**APPENDIX E: Transportation Operations Review. Fehr & Peers,
January 2023**

Transportation Operations Review of Chevron Gas Station & Krispy Krunchy Chicken Restaurant on Leisure Lane

Prepared for:
City of Sacramento, Department of Public Works

January 19, 2023

Image 3: SimTraffic modeling shows queue spillback on Exposition Boulevard under baseline plus project conditions. This condition exists currently but is exacerbated to a slight degree by the addition of project trips.

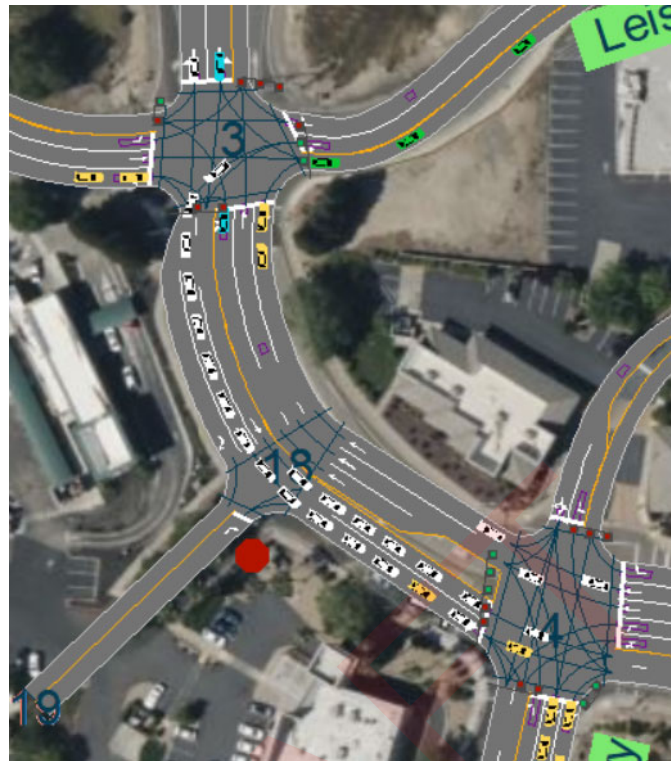
The eastbound Exposition Boulevard vehicle queues at Expo Parkway are marginally worse under baseline plus project conditions. As shown in **Image 3**, vehicles momentarily queue into the Leisure Lane/Exposition Boulevard/SR 160 Eastbound Ramps (#3) intersection. This type of intersection blockage rarely occurred in the microsimulation (i.e., one time or less on an average run) and did not impair operations at Intersection 3 beyond the cycle it occurred. Table 7 shows that off-ramp queuing at Intersection 3 is contained within available storage.
